MFN 06-262
Supplement 4

Subject: **Modified Reactor Building/Fuel Building Truncated Model,
SER-ESB-038 Rev. 5**

**Shimizu Engineering Report SER-ESB-038, Rev. 5,
“Modified RBFB Truncated FE Model Analysis Data,”**

Project	General Electric Company ESBWR Project	Shimizu Document No.	SER-ESB-038
Title	Modified RBFB Truncated FE Model Analysis Data	Rev.	5
		Issued Date	9/22/06
		Revised Date	1/9/07

Figure C-17 Element Forces Comparison NASTRAN to ANSYS (F3 Wall: Axial Force [MN/m])

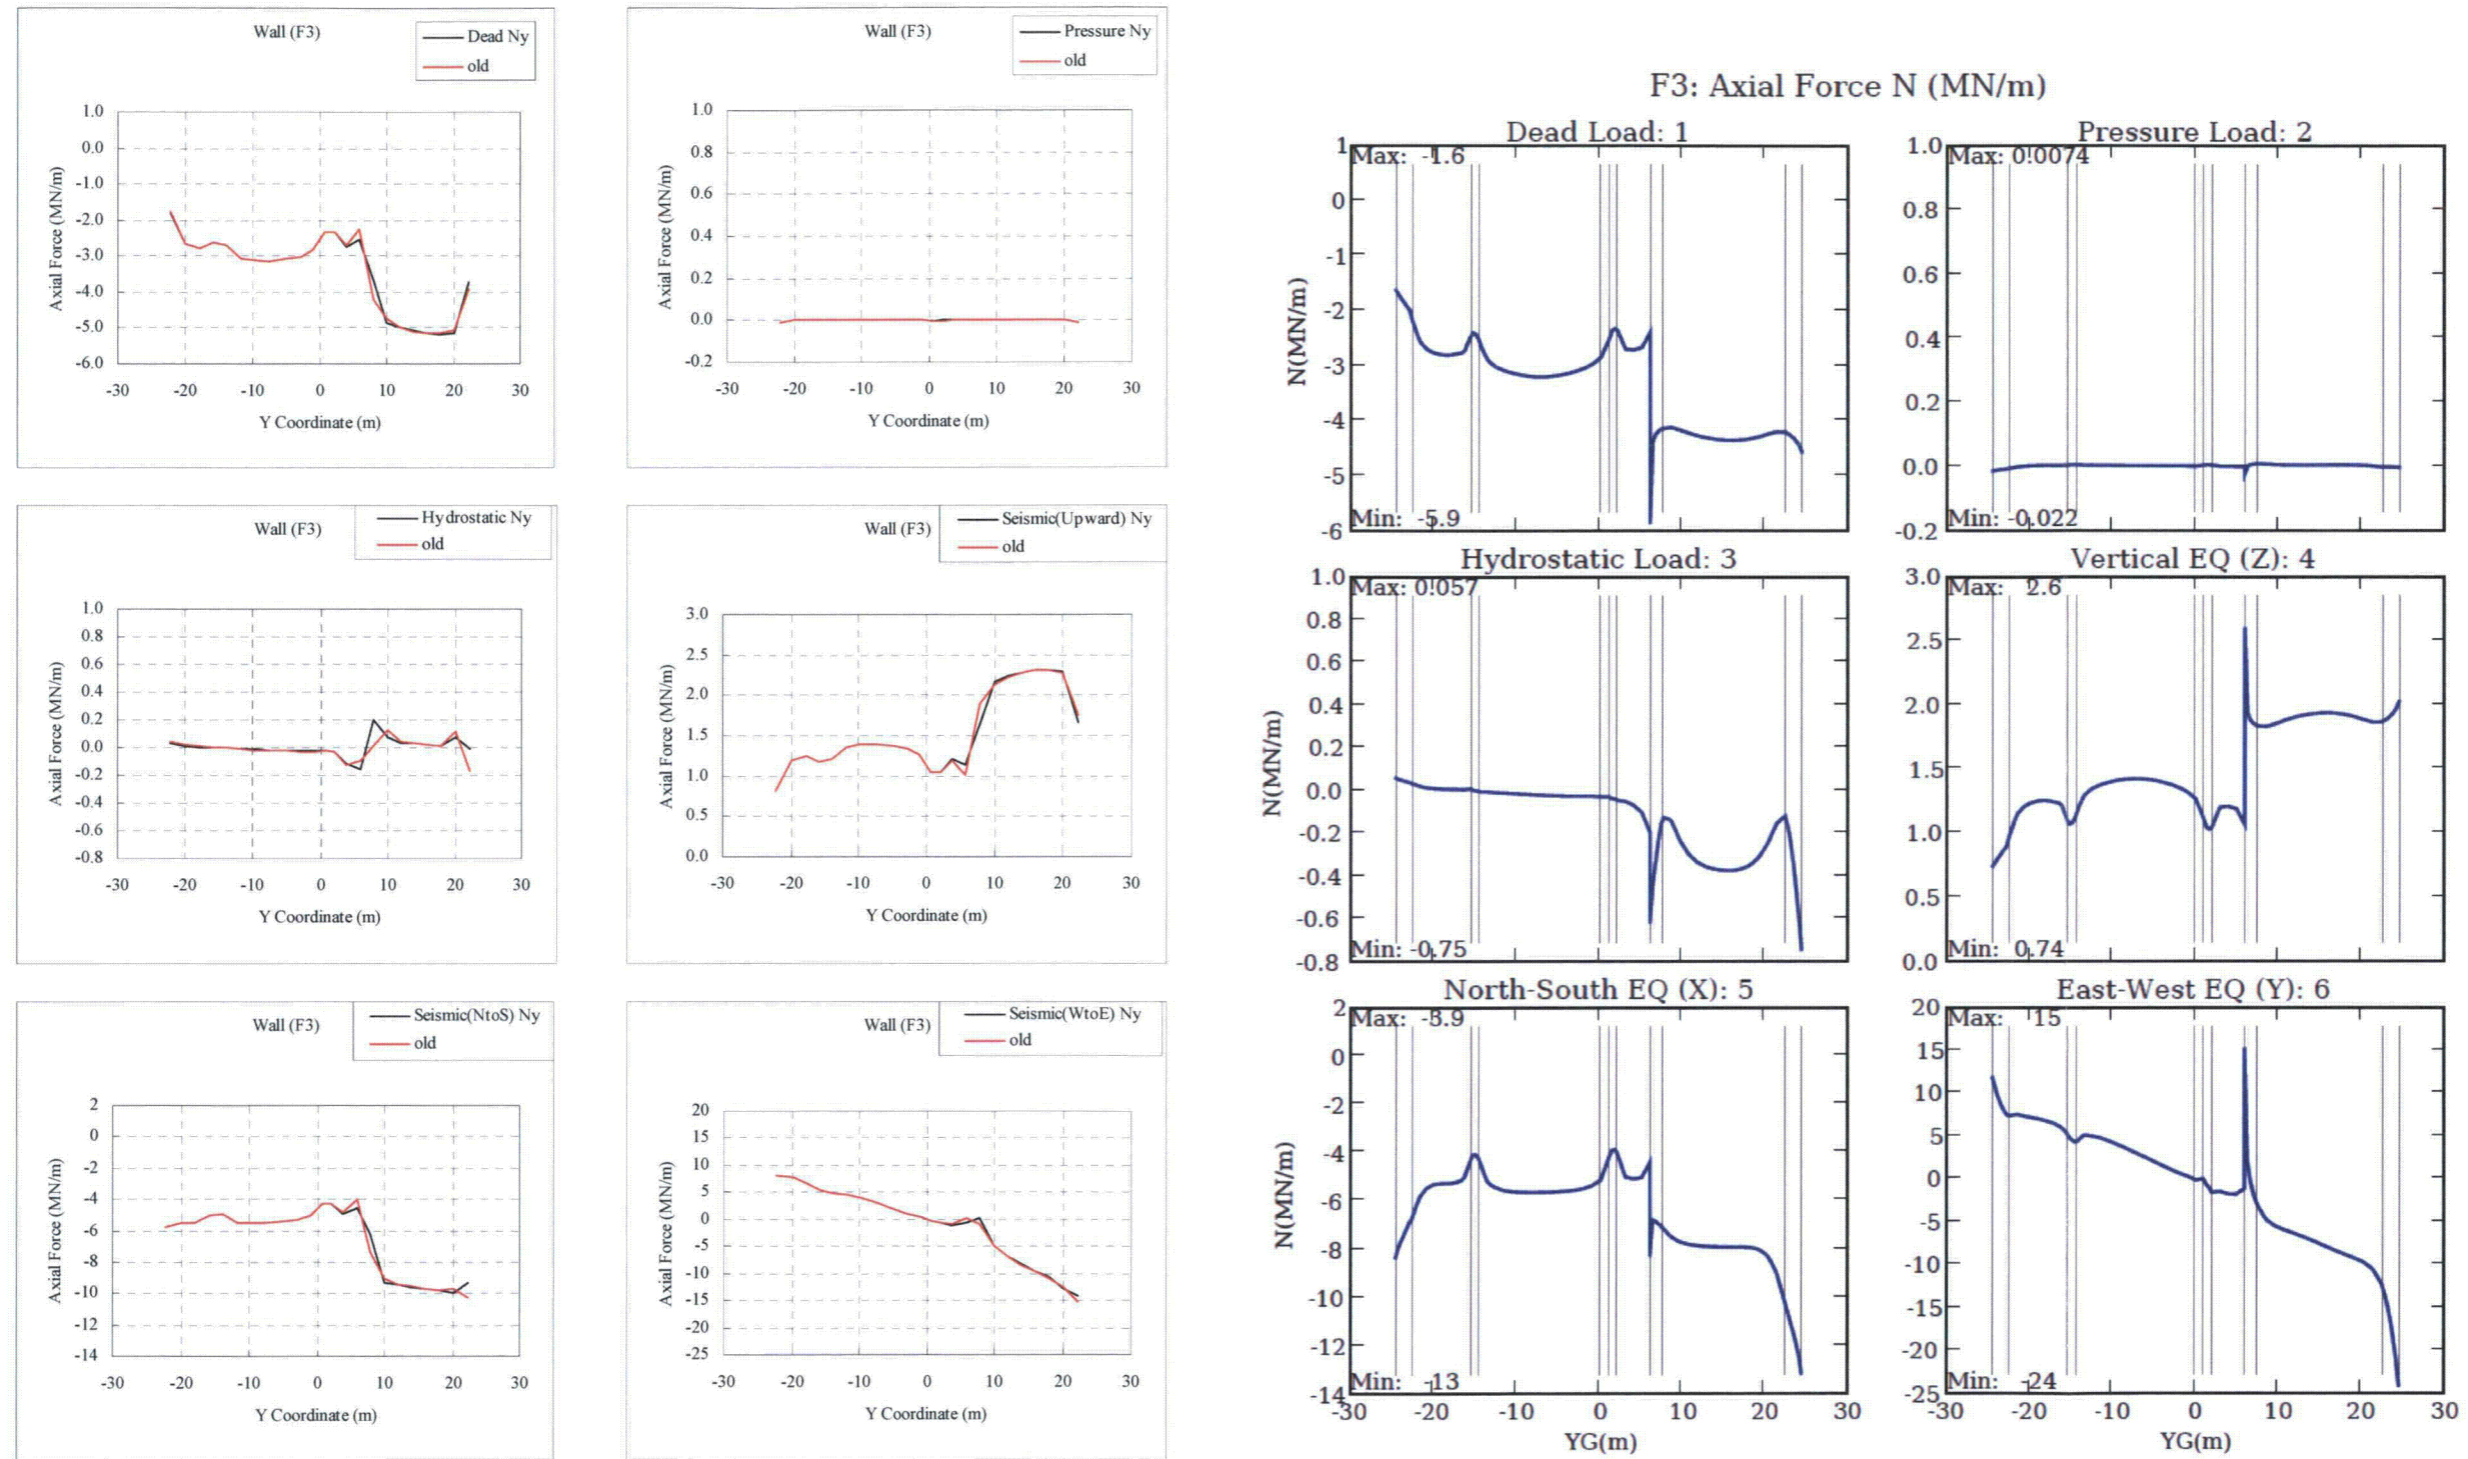
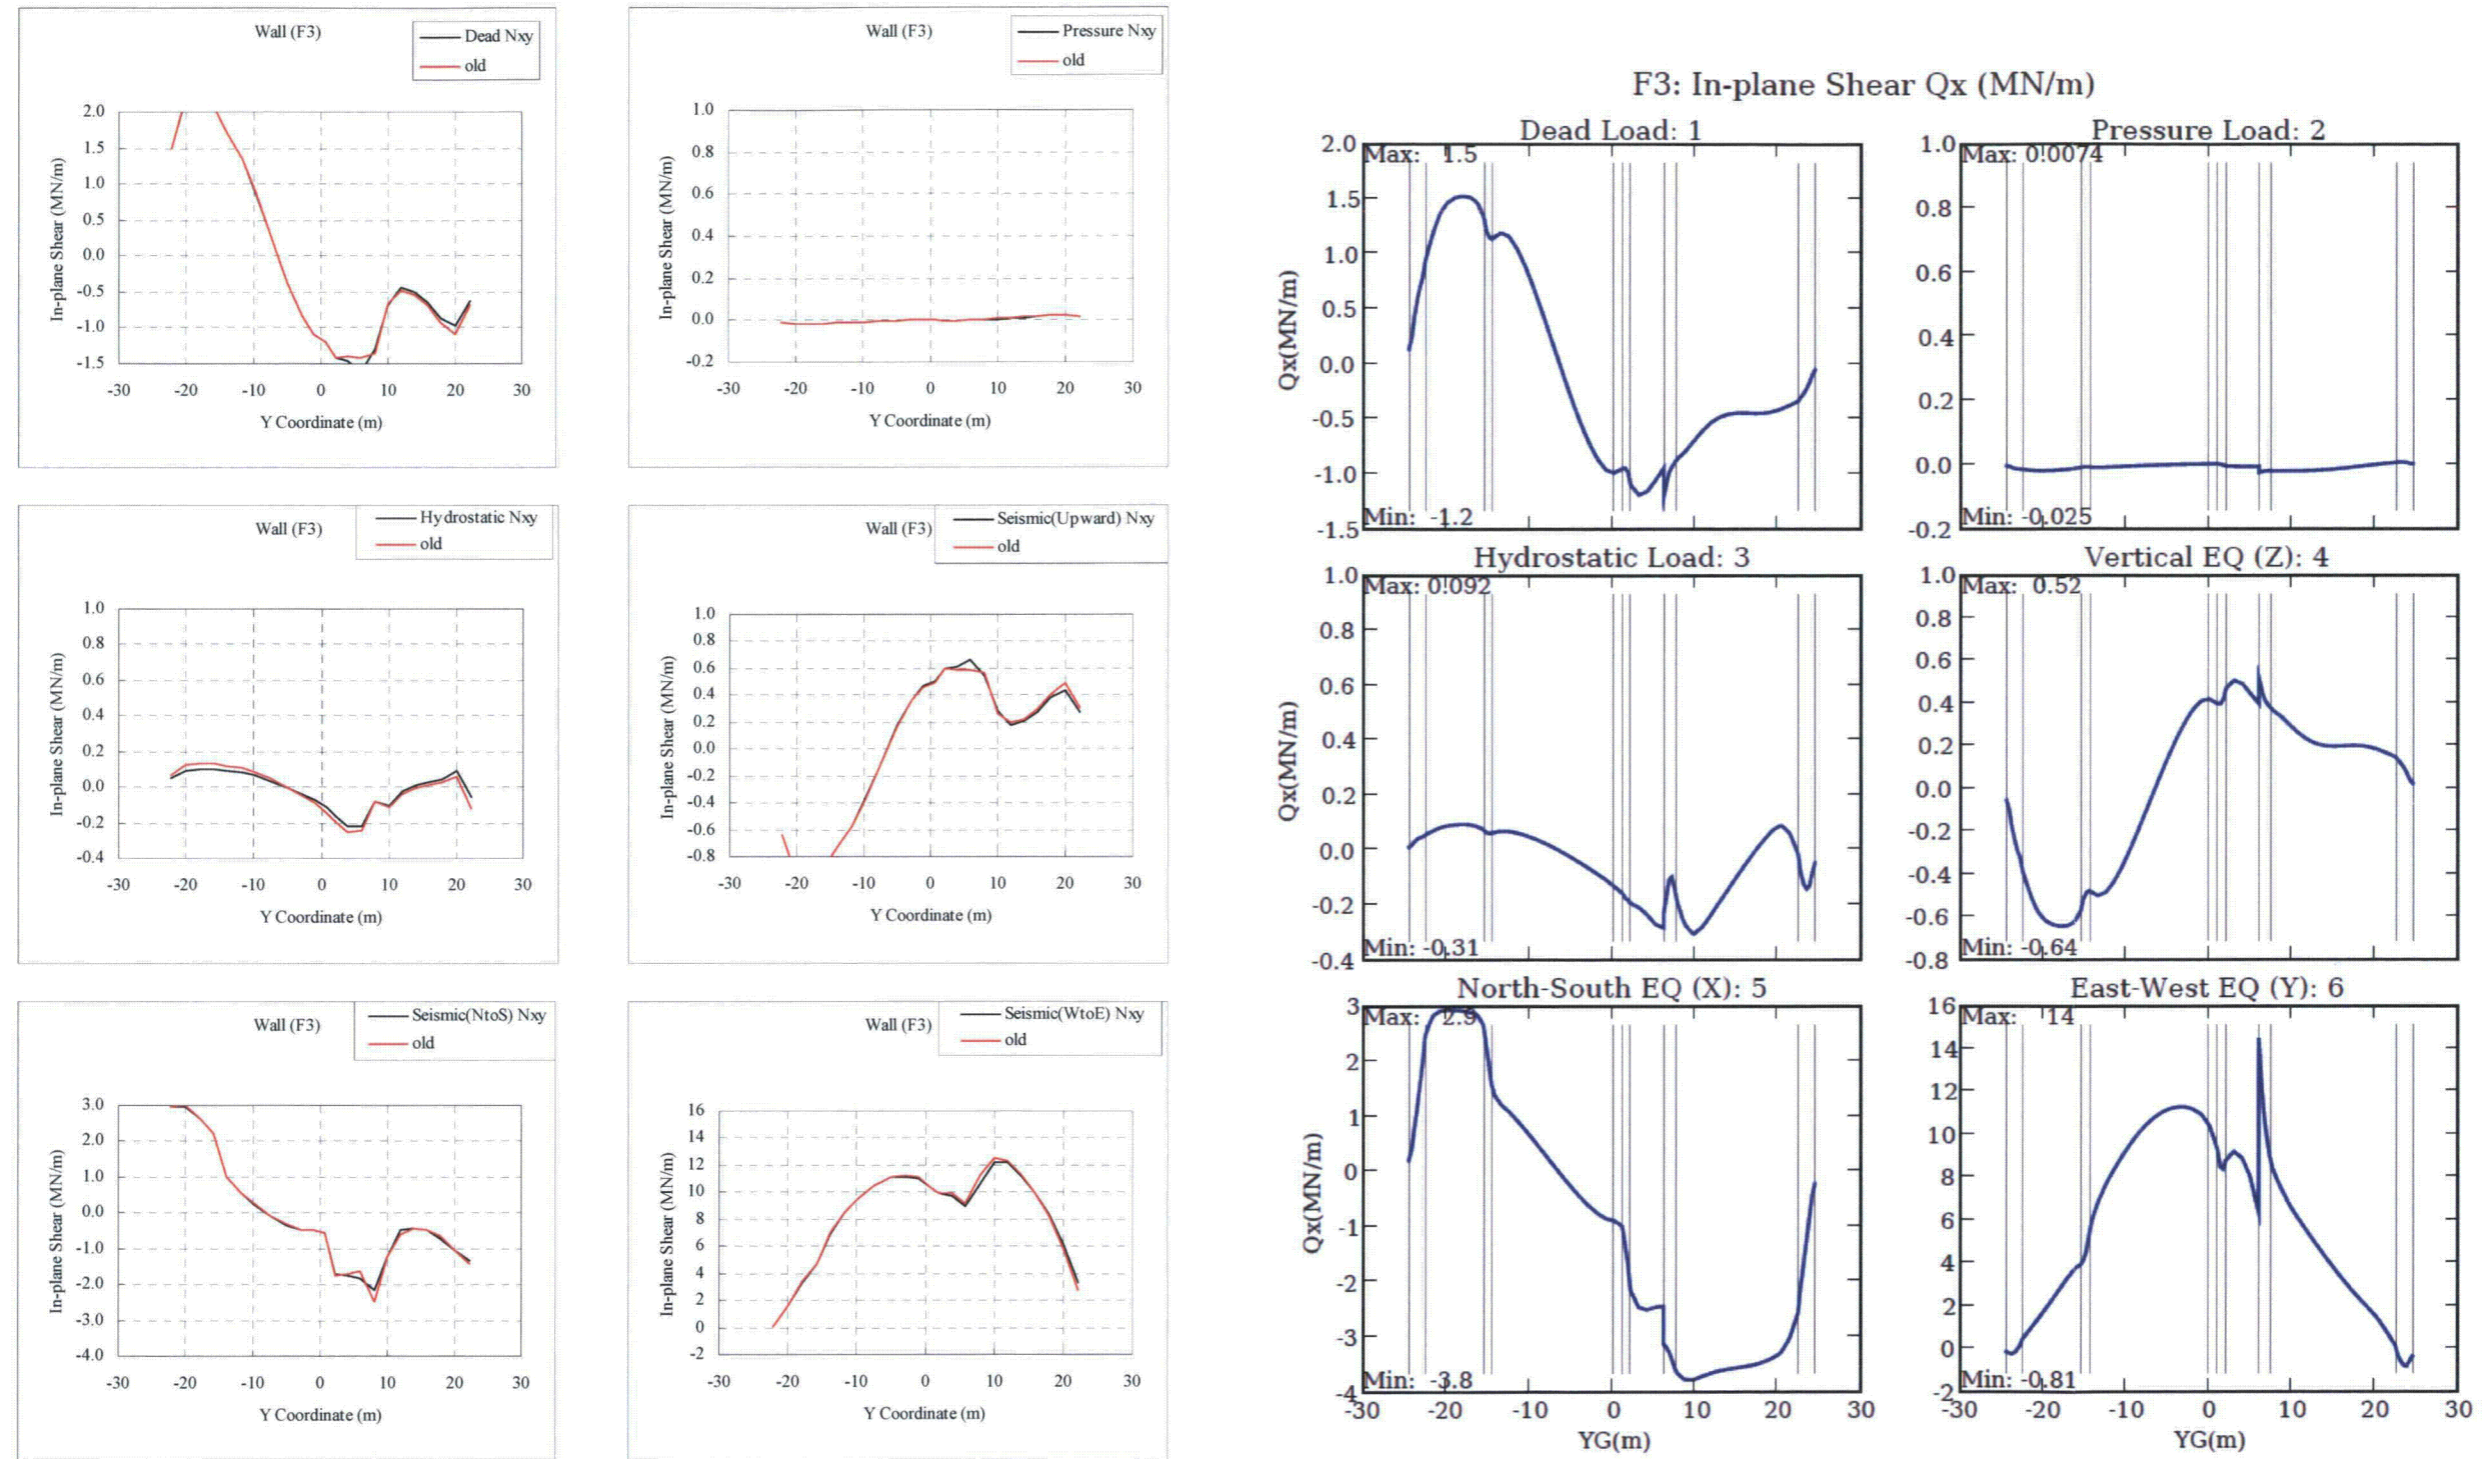
- iii) *The differences of magnitude of forces appeared on basemat inside pedestal:* The result of re-analysis using the updated model shows better agreement. In case of seismic load the magnitude of forces has to be re-compared because BNL's soil spring may not be adequate as pointed out above 3).

- iv) *The differences of magnitude of forces appeared on outer wall of Fuel Storage Pool (FSP):* For the out-of-plane shear forces and moments on RA and F3 wall located around FSP in case of Hydrostatic load, BNL's results are lower than those of GE. GE assumes the some part of differences comes from the difference of estimation levels between both models as pointed out above 8). In order to have a better understanding of the differences, GE would like to request BNL to confirm the input data for Hydrostatic load.
